Access Compliance Report

Public Rights-of-Way

Intersection ID: 44190	Main Street: ROZZELLES_LANDING_DR	Cross Street: CODDINGTON_RIDGE_DR	Location: SE
ADA ID: 30BD2743508D	Ramp Type: Perp	Initial Pass/Fail: Fail	Overall Compliance: No
Codes/Mitigation Info/Possible Solution		Field Measurements/Component Compliance	
Severity Score: 8.75

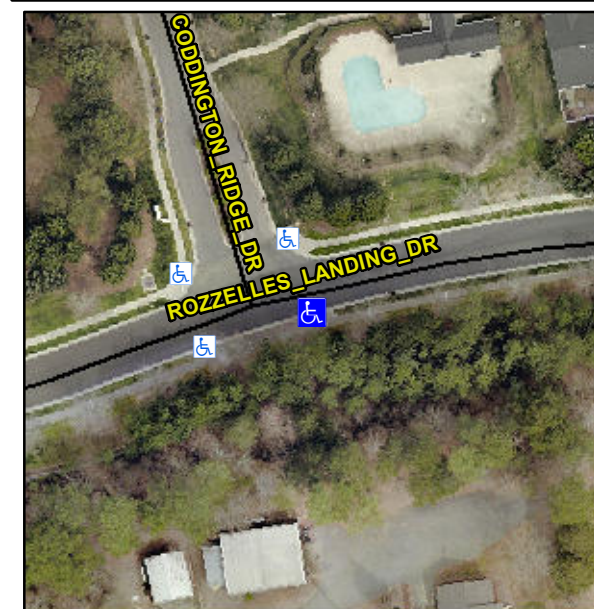
Compliance	Description	Data	Compliance	Description	Data
N/A	Ramp Length (in)	47.0	Yes	Ramp Slope (%)	6.9
No	Ramp Width (in)	47.0	Yes	Ramp XSlope (%)	1.4
N/A	Flare Type LT	N/A	N/A	Flare Type RT	N/A
N/A	Flare Slope LT (%)	N/A	N/A	Flare Slope RT (%)	N/A
N/A	Flare Traversable LT?	N/A	N/A	Flare Traversable RT?	N/A
N/A	Landing Length (in)	N/A	N/A	DWS Provided?	N/A
N/A	Landing Width (in)	N/A	N/A	DWS Contrast?	N/A
N/A	Landing Slope (%)	N/A	N/A	DWS Length (in)	N/A
N/A	Landing X Slope (%)	N/A	N/A	DWS Full Width?	N/A
N/A	Landing Curb? (Y/N)	N/A	N/A	DWS Offset (in)	N/A
N/A	Shared Landing?	N/A			
N/A	Gutter Ponding?	N/A	N/A	Gutter Slope (%)	N/A
N/A	Gutter Lip Ht (in)	N/A	N/A	Gutter X Slope (%)	N/A
N/A	Painted X Walk1?	No	N/A	Painted X Walk2?	N/A
	X Walk 1 Direction	To N		X Walk 2 Direction	N/A
N/A	X Walk 1 Width (in)	N/A	N/A	X Walk 2 Width (in)	N/A
	X Walk 1 Slope (%)	4.8		X Walk 2 Slope (%)	N/A
	X Walk 1 X Slope (%)	0.8		X Walk 2 X Slope (%)	N/A

N/A	Ramp inside XWalk1?	N/A	N/A	Ramp inside XWalk2?	N/A
	Road Slope (%)	N/A	N/A	Clear Space?	N/A
	Road X Slope (%)	N/A	N/A	Clear Space to XWalk (in)	N/A
N/A	Any Obstructions?	N/A	N/A	Storm Grate/Utility Hazard?	N/A
	Obstruction Type			Storm Grate/Utility Type	
		N/A			N/A
		Yes		Surface Condition? (G/P)	Good

Remove & Replace Entire Ramp.

R304.5.1
